1963 Corvette: Service News: Hydraulic Steering Hose Interference

Source: Chevrolet Service News

Number: Volume 34, Number 11, Page 2.

Date: December, 1962

Fig. 1—Adding Strap to Corvette Steering Hoses

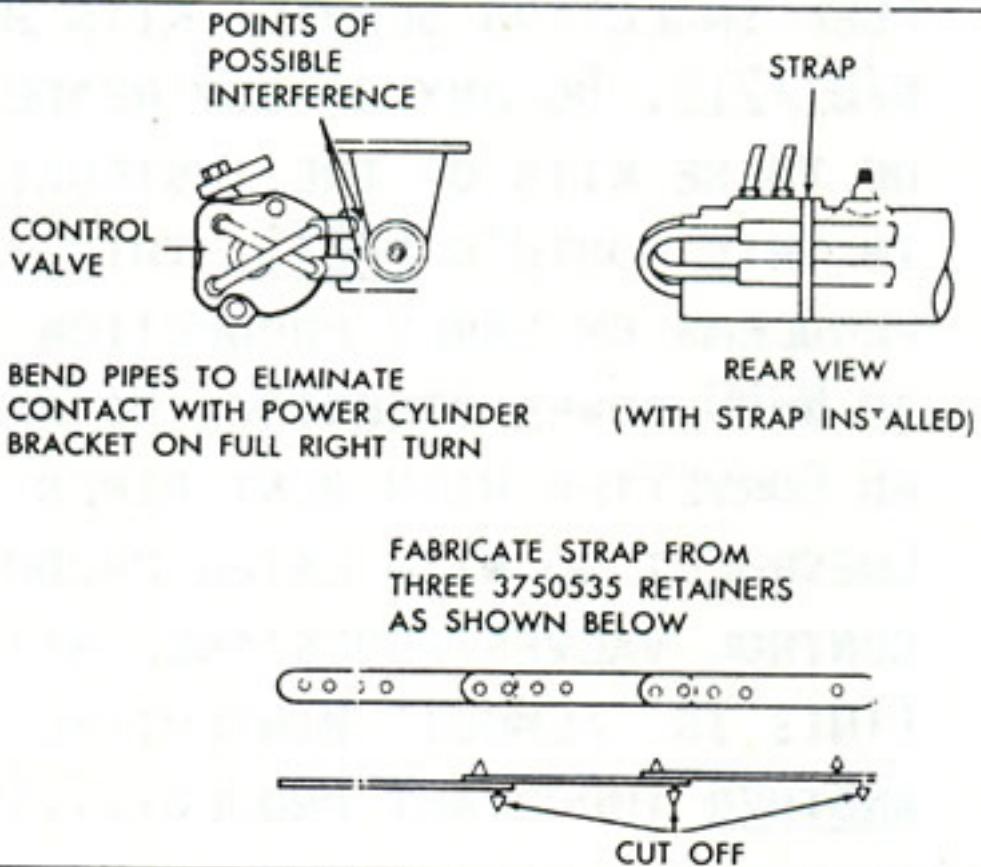
On early production 1963 model Corvette vehicles, interference, in some cases, may be encountered between the hydraulic steering control valve power cylinder hoses and the hydraulic steering cylinder frame bracket. This would occur when the wheels are moved into a full right turn. If this condition is experienced, the hose pipes at the control valve should be bent to provide clearance and then strapped with three Part No. 3750535 Retainers as shown in Figure 1.
